AGENDA

February 15, 2024, Standards Committee Meeting

RE: Agenda for the February 15, 2024, Standards Committee Meeting

REVISION TO SPECIAL PROVISIONS AND STANDARD DRAWINGS

INDIANA DEPARTMENT OF TRANSPORTATION	
PEDESTRIAN DETOUR MIDBLOCK CLOSURE	
SEPTEMBER 2024	
STANDARD DRAWING NO. E 801-TPAR-06	
	DESIGN STANDARDS ENGINEER _____ DATE _____
	CHIEF ENGINEER _____ DATE _____

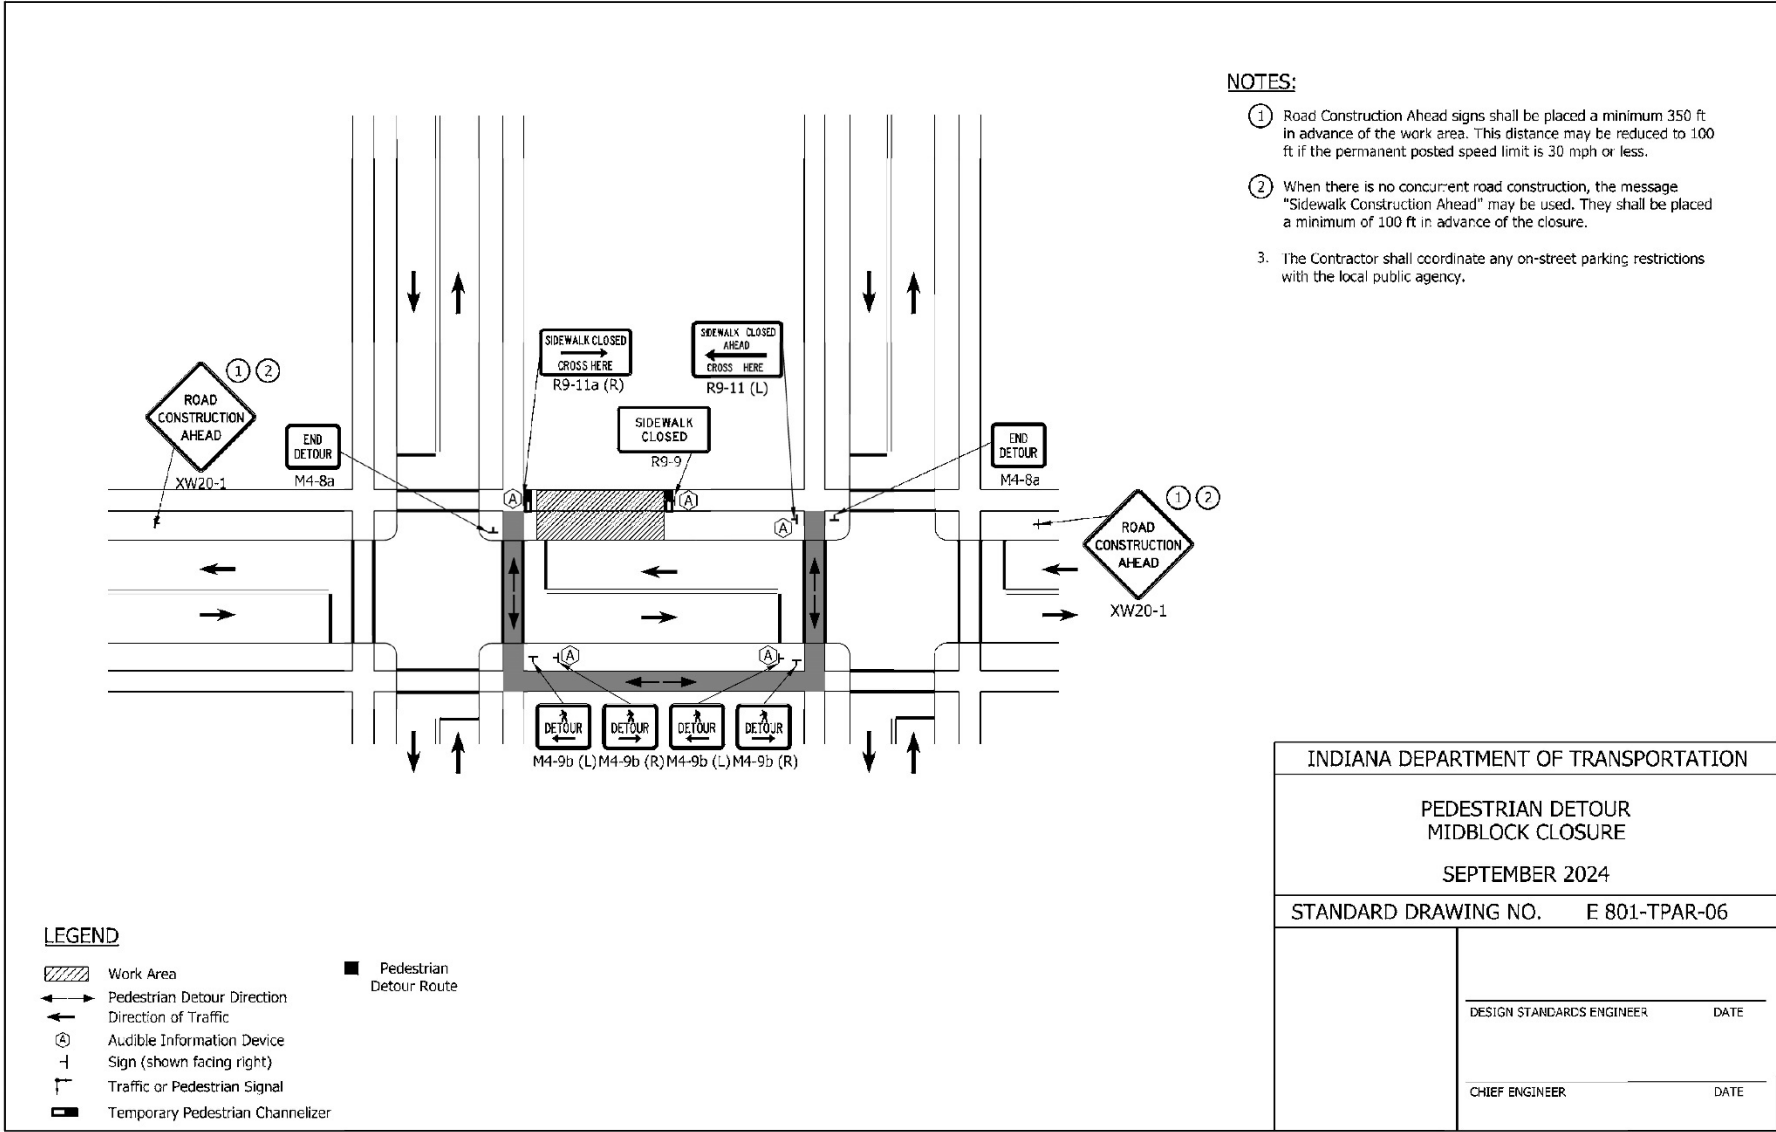
- NOTES:**
- ① Road Construction Ahead signs shall be placed a minimum 350 ft in advance of the work area. This distance may be reduced to 100 ft if the permanent posted speed limit is 30 mph or less.
 - ② When there is no concurrent road construction, the message "Sidewalk Construction Ahead" may be used. They shall be placed a minimum of 100 ft in advance of the closure.
 - 3. The Contractor shall coordinate any on-street parking restrictions with the local public agency.

STANDARD DRAWING NO. **E 801-TPAR-10**

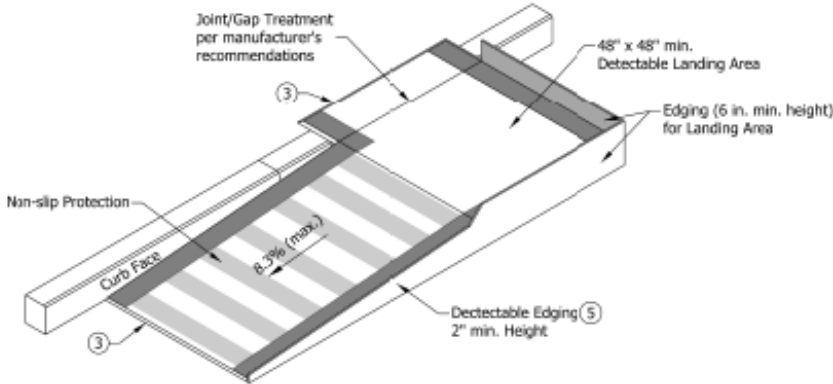
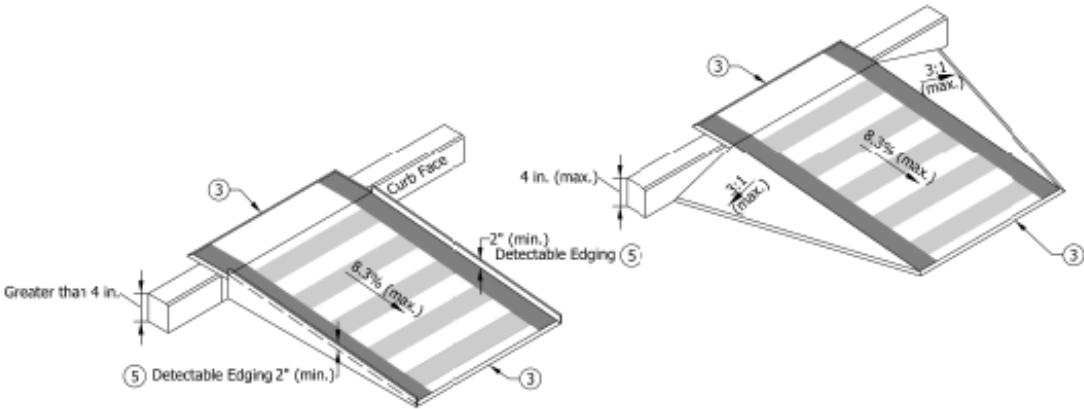
1. Water flow in the gutter system shall be maintained.
2. Lateral joints or gaps between surfaces shall be less than 0.5 in. width.
- ③ Changes in level between surface heights shall not exceed 0.5 in. Lateral edges shall be vertical up to 0.25 in. high, and beveled at 2:1 between 0.25 in. and 0.5 in. in height

4. Handrail shall be provided along a landing area and ramp where the elevation difference between the sidewalk and the street is greater than 6.0 in.
- ⑤ A 2.0 in. detectable edge shall be provided along the entire length of the ramp where the elevation difference between the sidewalk and the street is greater than 4.0 in.

6. The rise of a single temporary curb ramp shall be no more than 30 in. If more than one temporary curb ramp is needed at a location due to the change in elevation, a minimum 5 ft landing area shall be used between curb ramps. The landing area shall have a slope of less than 2.0%.

7. The table below is for common curb heights, the curb ramp length for other curb heights shall be based on having a maximum slope of 12:1.

INDIANA DEPARTMENT OF TRANSPORTATION	
TEMPORARY PEDESTRIAN CHANNELIZERS	
SEPTEMBER 2024	
STANDARD DRAWING NO.	E 801-TPAR-11
DESIGN STANDARDS ENGINEER	DATE
CHIEF ENGINEER	DATE

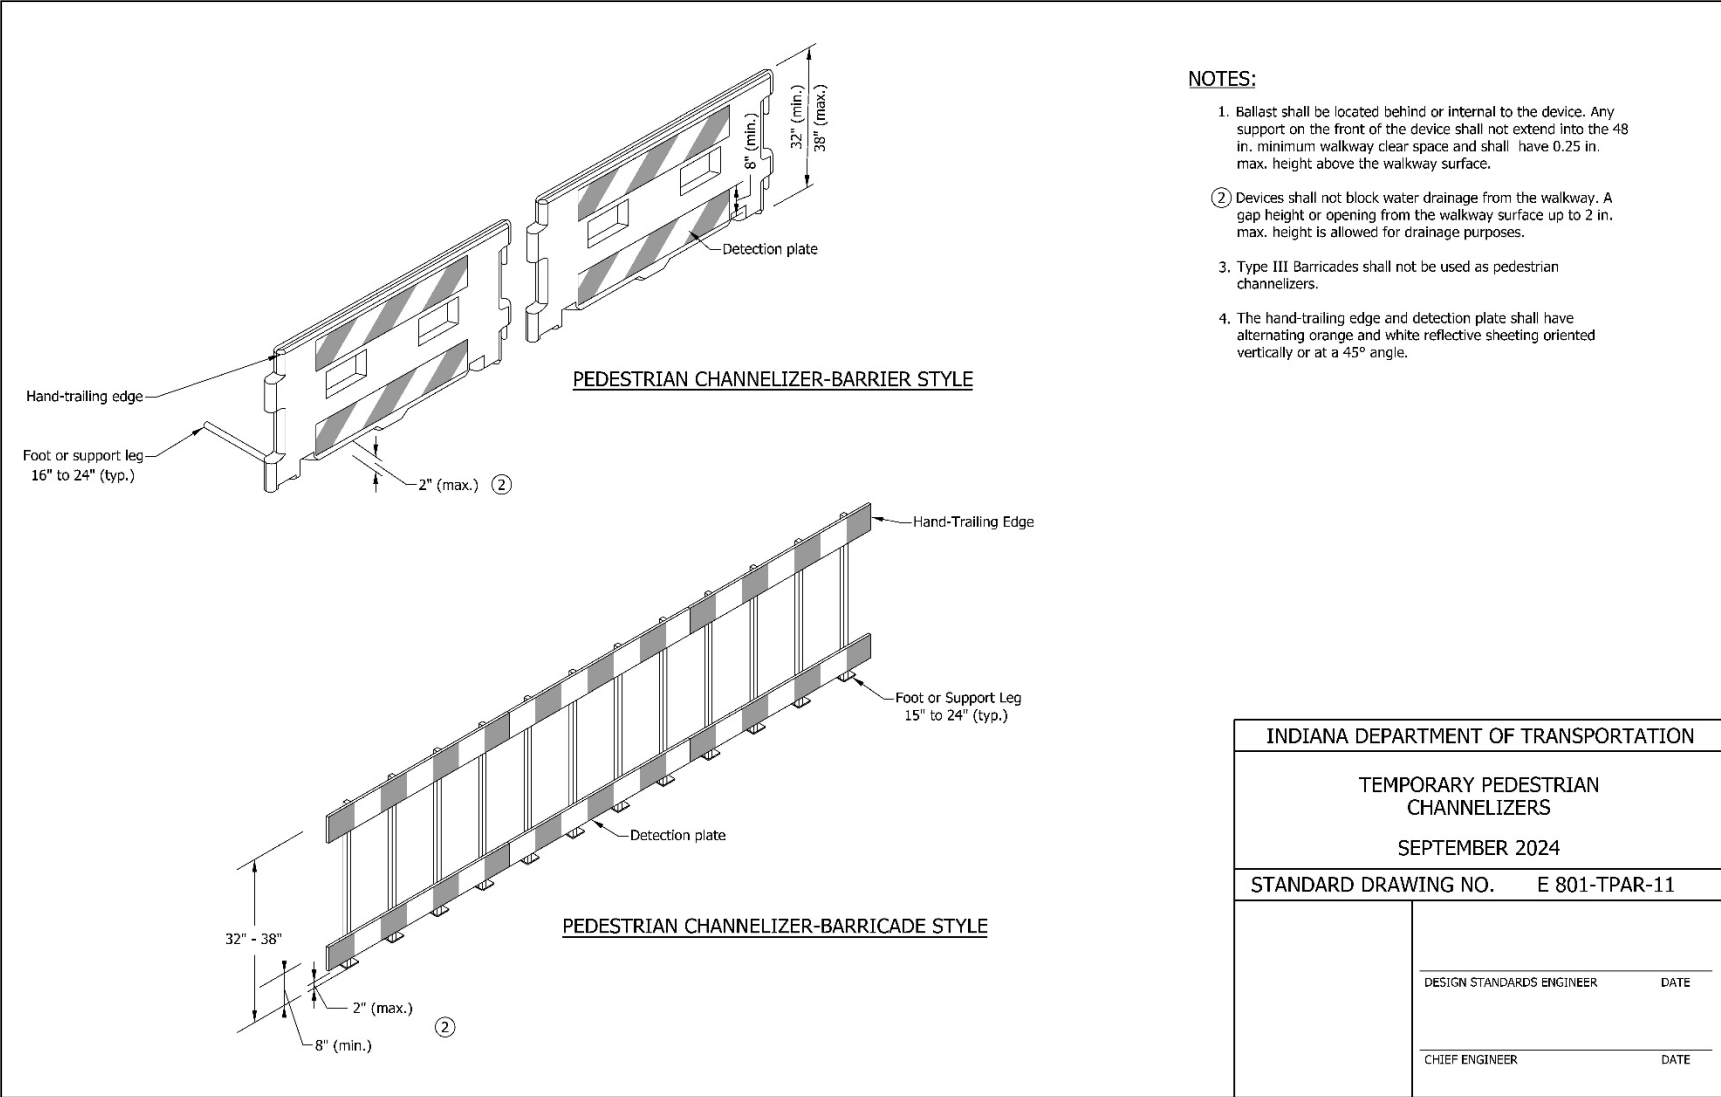
1. Ballast shall be located behind or internal to the device. Any support on the front of the device shall not extend into the 48 in. minimum walkway clear space and shall have 0.25 in. max. height above the walkway surface.
- ② Devices shall not block water drainage from the walkway. A gap height or opening from the walkway surface up to 2 in. max. height is allowed for drainage purposes.
3. Type III Barricades shall not be used as pedestrian channelizers.
4. The hand-trailing edge and detection plate shall have alternating orange and white reflective sheeting oriented vertically or at a 45° angle.
